Product Change Notice

Issue Date: September 18, 2019

Add SPIL Taiwan as Bump supplier

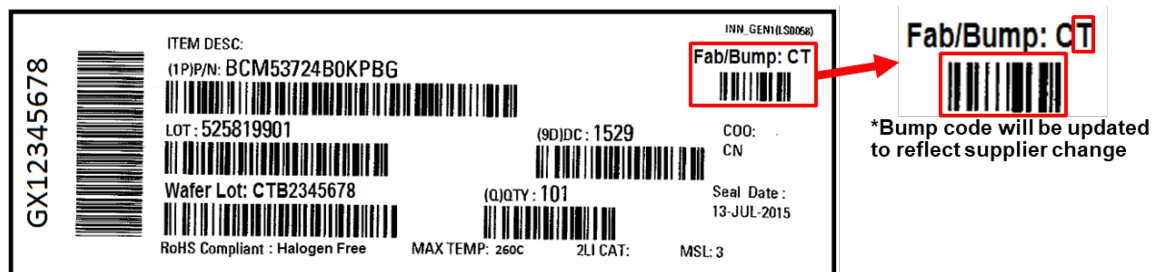
Description and Extent of Change:

Additional CuP Bump supplier - SPIL TAIWAN
